# **Responses to Requests for Additional Information on Topical Report WCAP-18483-P, “EnCore® Chromium Coated Cladding for Use in Pressurized Water Reactors.”**

**(Non-Proprietary)**

**April 2026**

Figure 7-5. Schematic overview of the HT steam oxidation process of Cr-coated zirconium-based (Zircaloy-type) alloys (Reference 7-2)

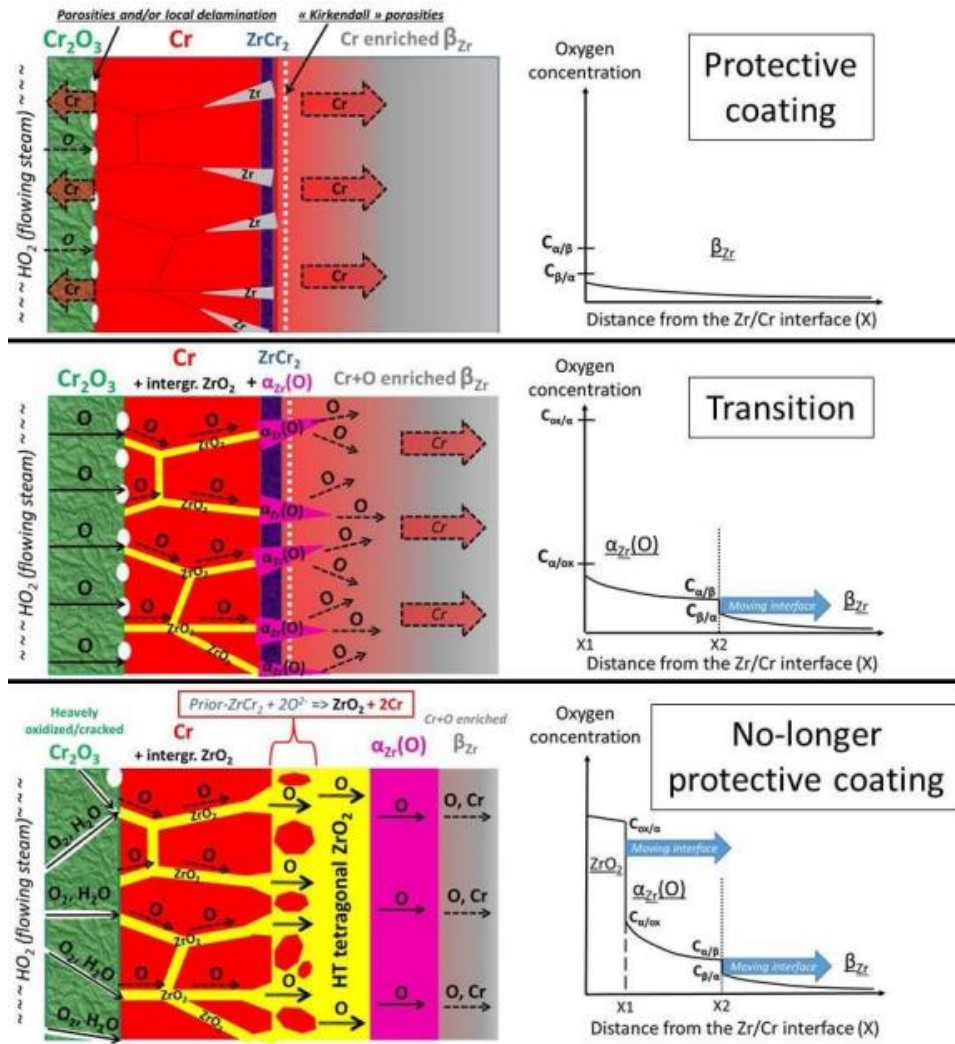
**Request for Additional Information #7**

Section 5.3.3 of the TR states that the non-LOCA [

This change in performance with increasing time and temperature can be explained by the microstructural evolution that occurs for Cr coated cladding including diffusion of Cr, formation of oxygen-stabilized alpha-Zr ( $\alpha_{Zr}(O)$ ), and eventual formation of  $ZrO_2$ . As the time/temperature increases, the Cr coating begins to diffuse into the base cladding alloy along grain boundaries (lightly seen below the  $ZrCr_2$  layer in Figure 7-4b and the inset of 4c), a thin intermetallic layer ( $ZrCr_2$ ) begins to form at the coating interface (as described in Section 3.11.2.3 of WCAP-18483-P), and the coating oxidizes, all resulting in consumption of the protective coating layer. Eventually, there is a shift as the coating begins to transition between protective and non-protective stages where the oxygen reacting with the Cr also diffuses into the cladding to form  $\alpha_{Zr}(O)$ . At longer oxidation times and higher temperatures above 1300°C, the coating can transition such that the residual Cr is non-protective and the underlying Zr can oxidize to form  $ZrO_2$  and a eutectic microstructure of diffused Cr and Zr can form (Figures 7-4a and 7-4c). The microstructural evolution is described well in (Reference 7-2) and schematically shown in Figure 7-5.
